From: John Neel
Sent: Friday, June 28, 2019 12:57:23 AM
To: Kali Casper; Kinsey O'Shea; Joshua Middleton; rformica@blacksburg.gov
Cc: Ellen Rodgers; Andrew Costas; Sarah C. Weir (sweir@gayandneel.com); Elliott Delp; Jay Clapp; Sherry Sadai
Subject: The Standard at Blacksburg - Revised Master Plan(JN2907.00)

**THE STANDARD
 SITE DEVELOPMENT PLAN**

ISSUE DATE	06/27/2019
GNIJOB NO.	2907.0
SHEET TITLE	PRELIMINARY SITE PLAN
SHEET NUMBER	C2-00

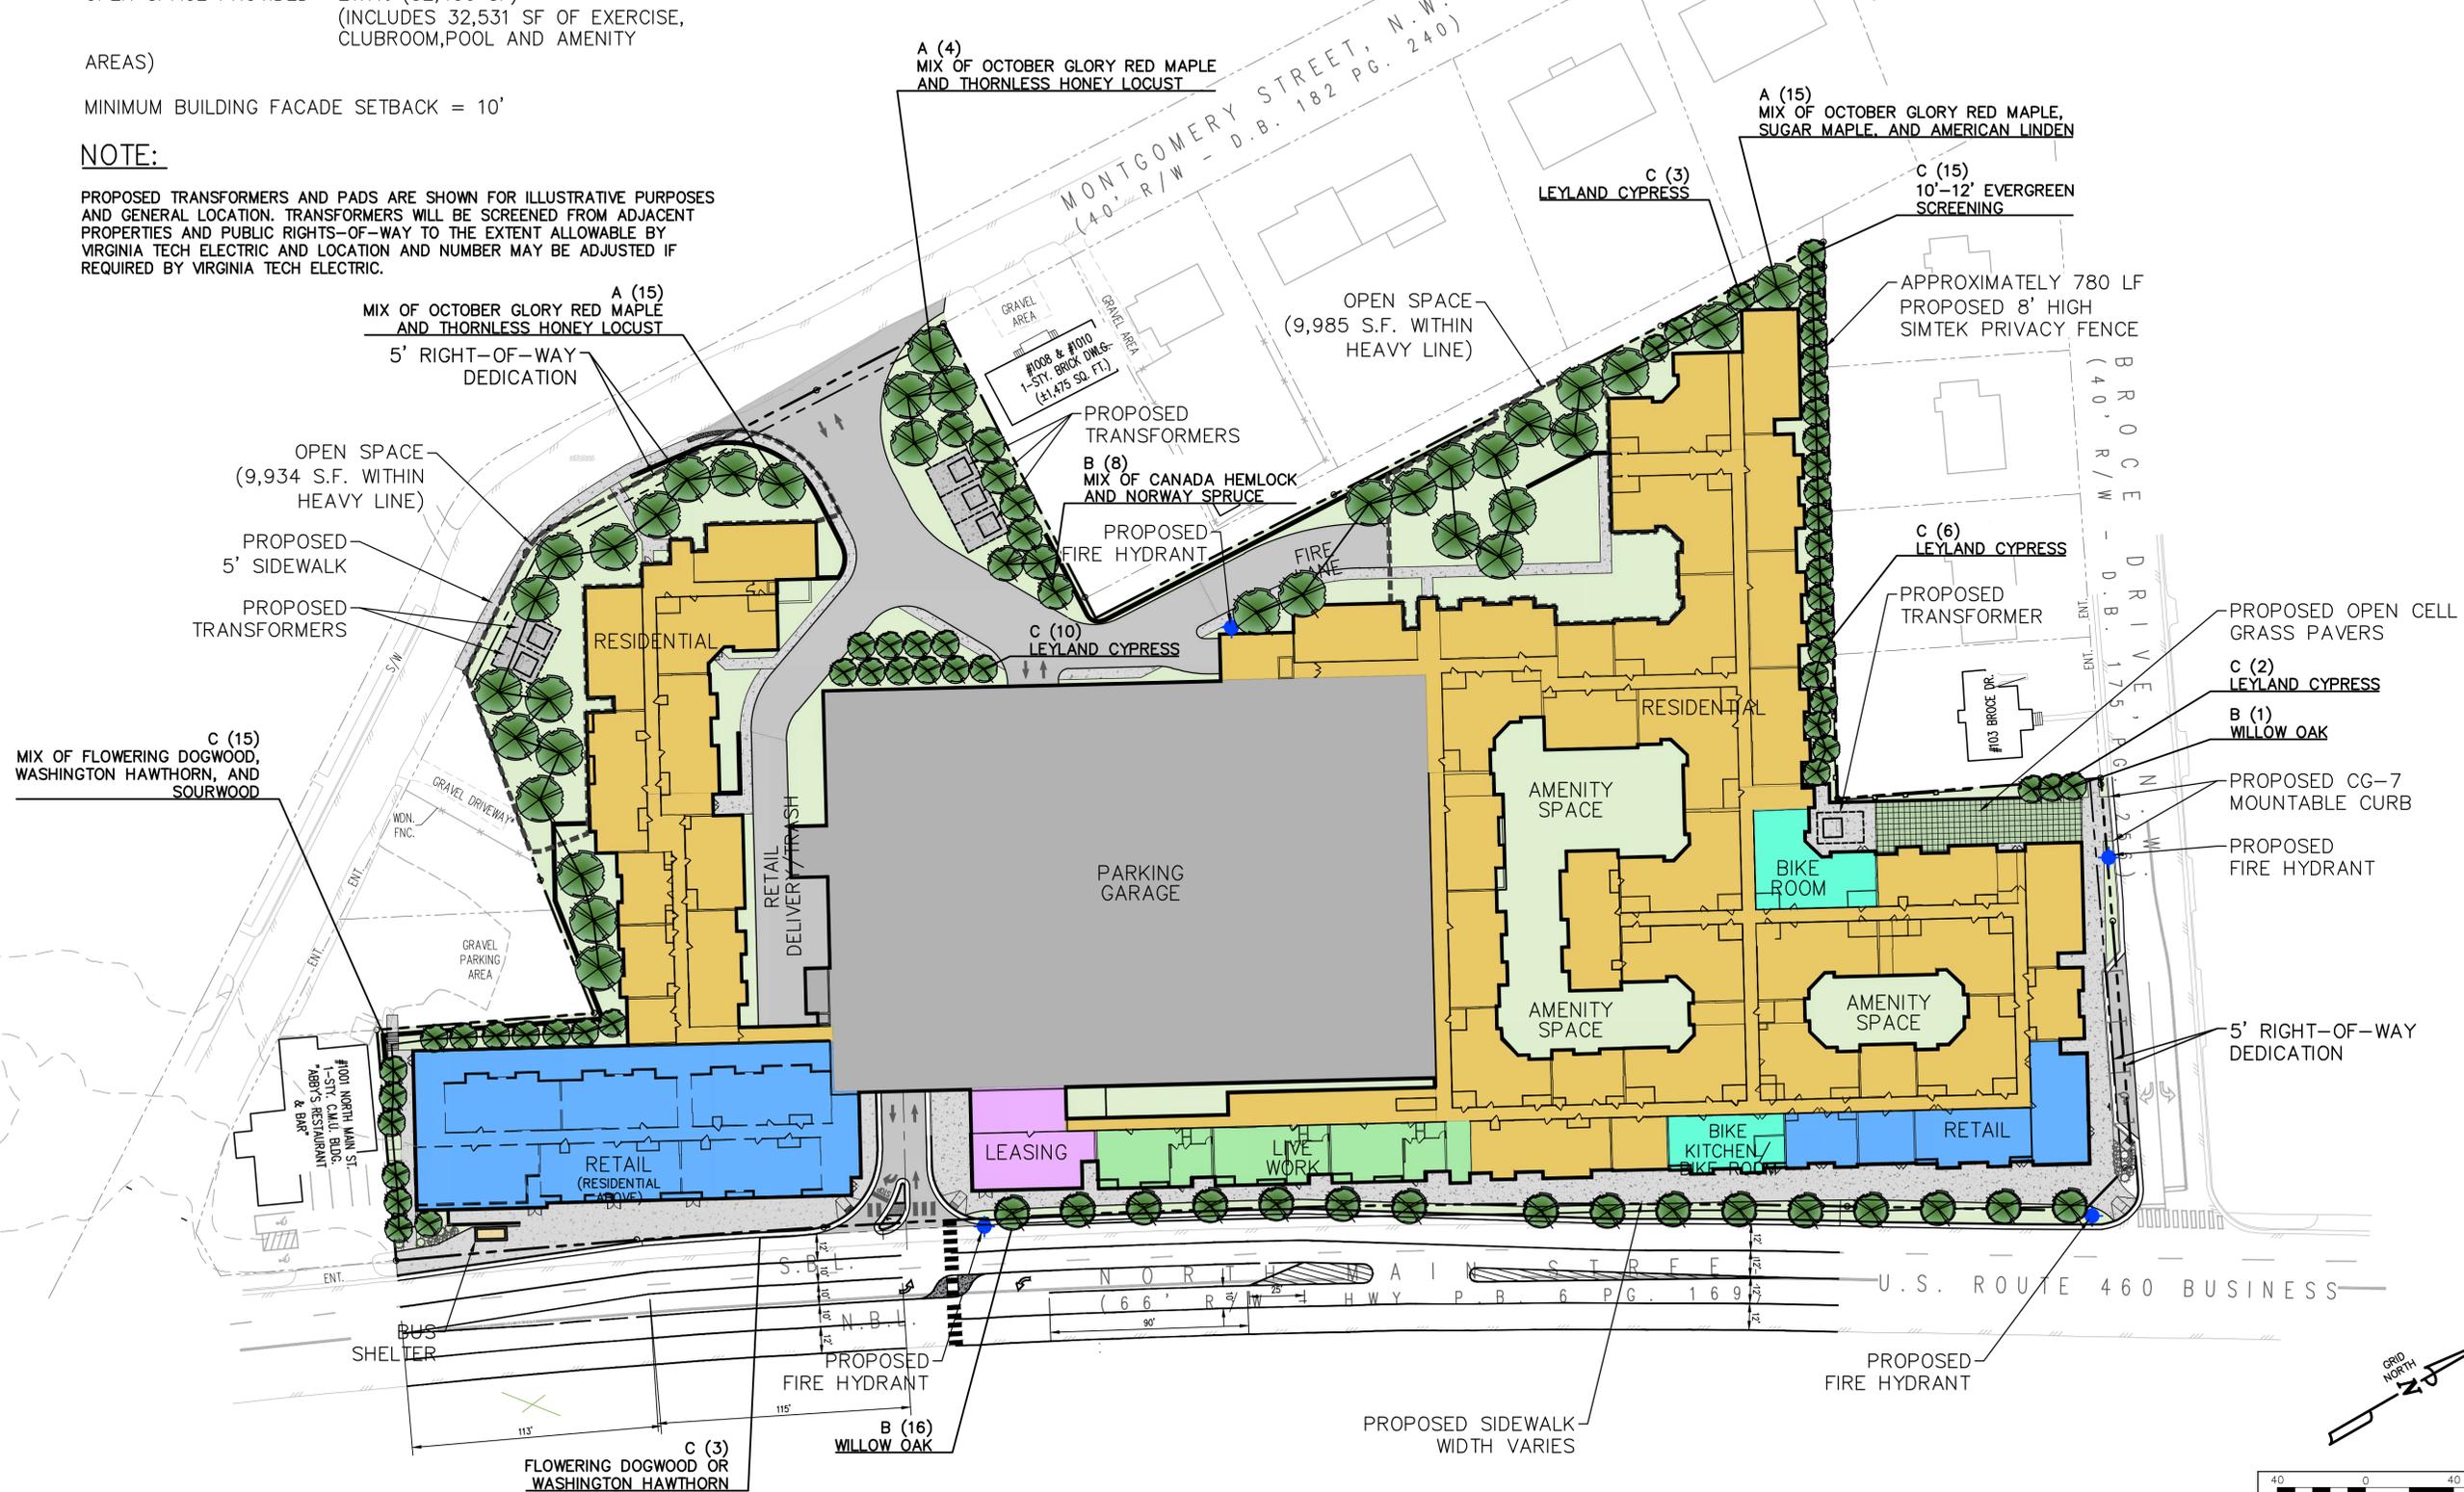
All – Please find attached the revised Master Plan for the project. We have illustrated the proposed fire hydrant locations, additional Simtek fencing, additional landscaping, and we have incorporated a pedestrian refuge island on North Main street as seemed highly desired by Planning Commission. In doing so, we have also been able to accommodate a left turn lane for the site access as well as the existing YMCA property for its use. These changes were precipitated by the comments heard at the Planning Commission Work Session as well as the refusal of the Abby's Restaurant parcel to grant an easement. Their refusal was not based on an opposition to the project but on the shape and size of their parcel as well as the impact an additional easement would have on their existing parking directly adjacent to the existing Right-of-Way.
